Staff Report to the Planning Commission

Application Number: **04-0598**

Project Description: Proposal to create a 12-lot subdivision from **three** parcels and to construct an off-site storm drain outlet and retaining wall. Requires a rezoning of Assessor's Parcel Numbers 049-201-15 and 049-201-16 from R-1-8 to R-1-6.

PRELIMINARY DRAINAGE PLAN

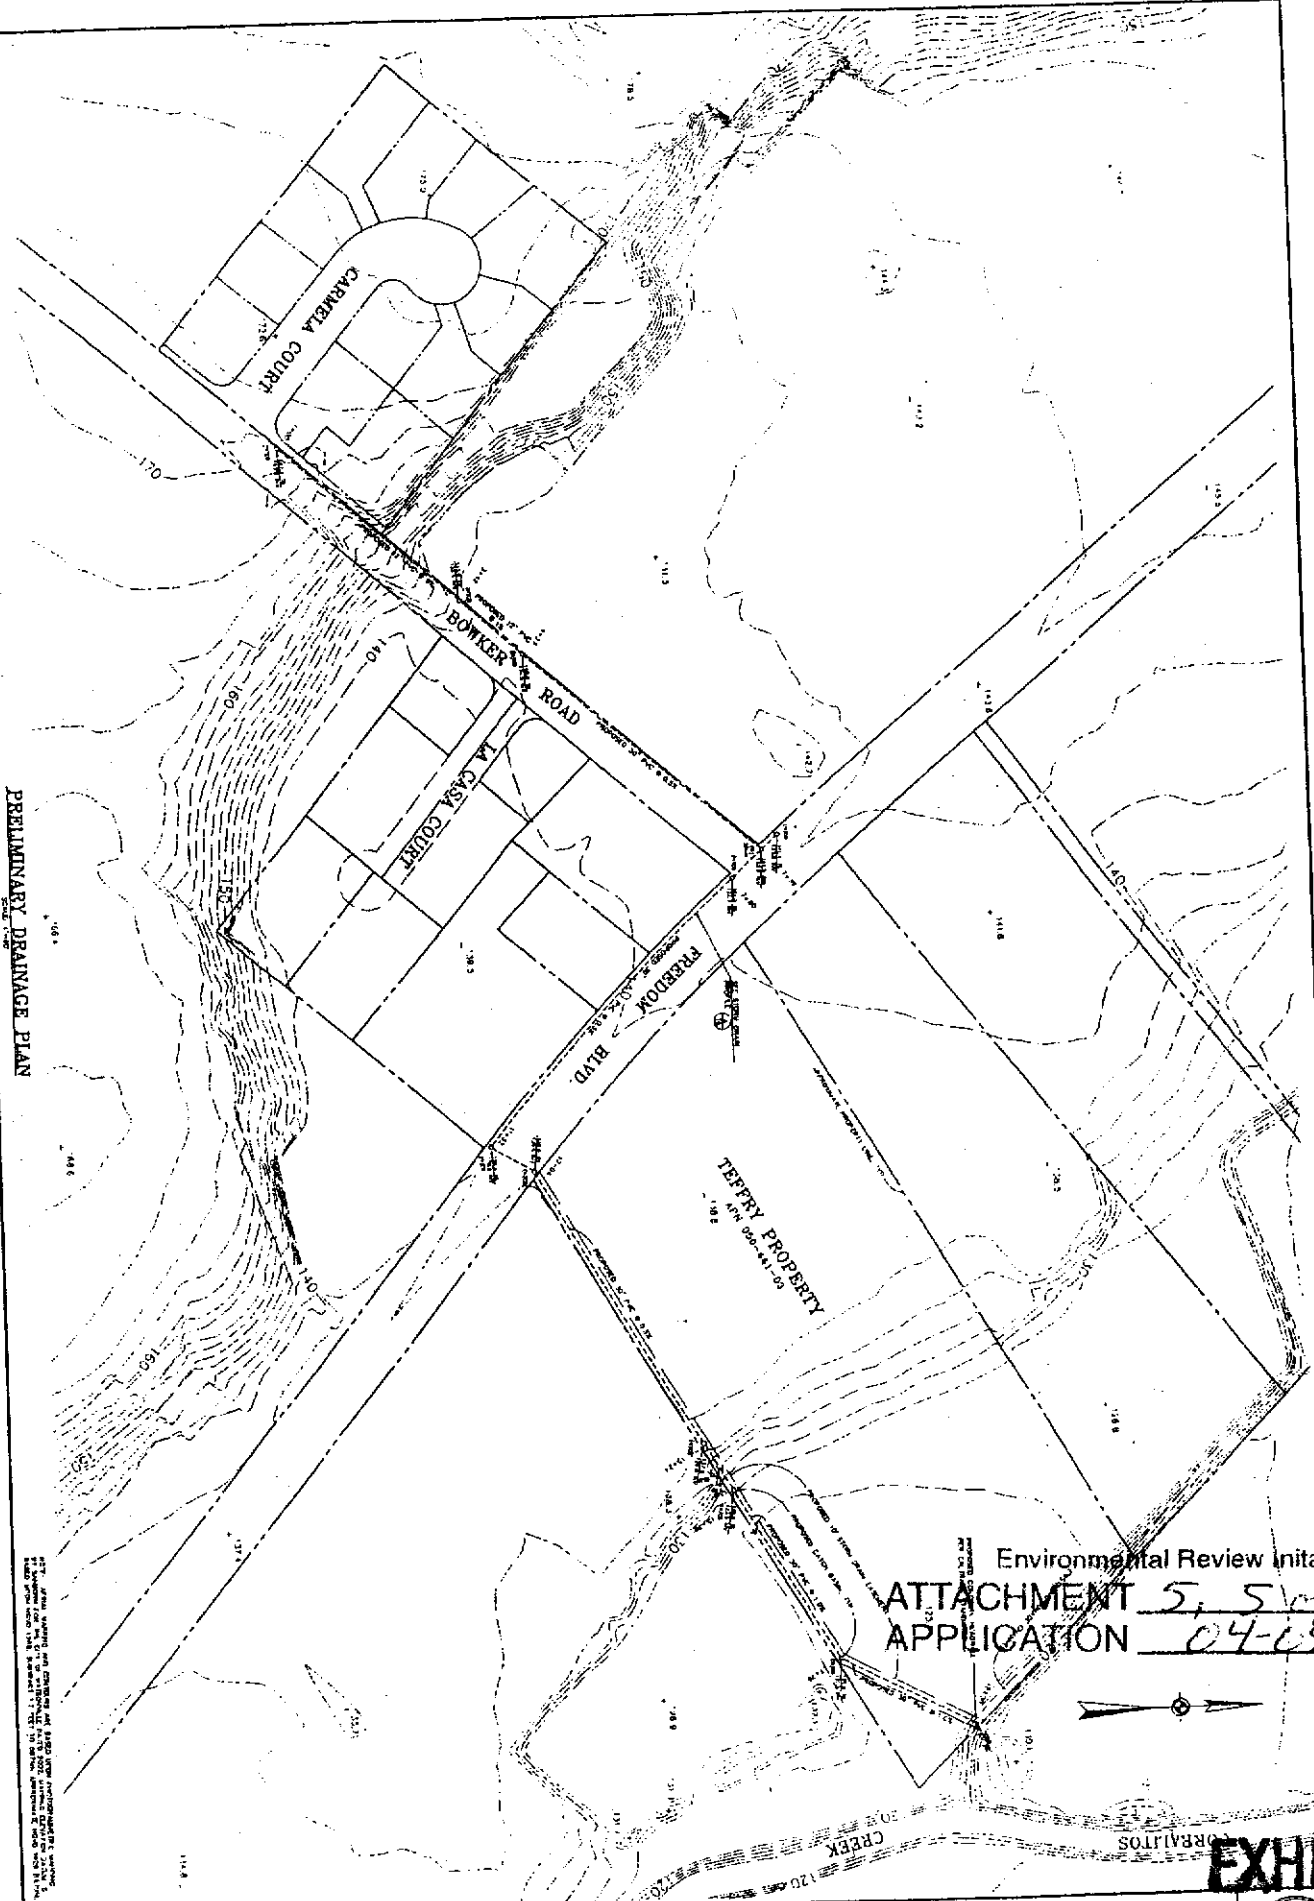
Sheet T3 – Provide finished floor elevations of lowest level of house with fixture connected to sewer to determine if backflow prevention requirements and note on plan if required to be installed. Where the finished floor elevation is one foot or less than the nearest upstream manhole rim elevation, it shall be noted on plans that the lot's sewer lateral shall require a sewer backflow/overflow prevention device per Figure SS-14.

Revise to show a cleanout at the end of the 6-inch segment of sewer lateral and one backflow prevention device on each 4-inch lateral connected to the 6-inch pipe per Figure SS-3. Remove note that indicates that backflow prevention device is to be installed on 6-inch pipe.

Sheet T5 – Note on plans that existing manhole in Bowker, at the proposed intersection with Cannella Court, shall be remortared on the inside or be replaced when modifying manhole to accommodate new 8-inch sewer mains.

Sheet T3 – Provide finished floor elevations of lowest level of house with fixture connected to sewer to determine if backflow prevention requirements and note on plan if required to be installed. Where the finished floor elevation is one foot or less than the nearest upstream manhole rim elevation, it shall be noted on plans that the lot's sewer lateral shall require a sewer backflow/overflow prevention device per Figure SS-I4.

Revise to show a cleanout at the end of the 6-inch segment of sewer lateral and one backflow prevention device on each 4-inch lateral connected to the 6-inch pipe per Figure SS-3. Remove note that indicates that backflow prevention device is to be installed on 6-inch pipe.

Sheet T5 – Note on plans that existing manhole in Bowker, at the proposed intersection with Cannella Court, shall be be remortared on the inside or be replaced when modifying manhole to accommodate new 8-inch sewer mains.
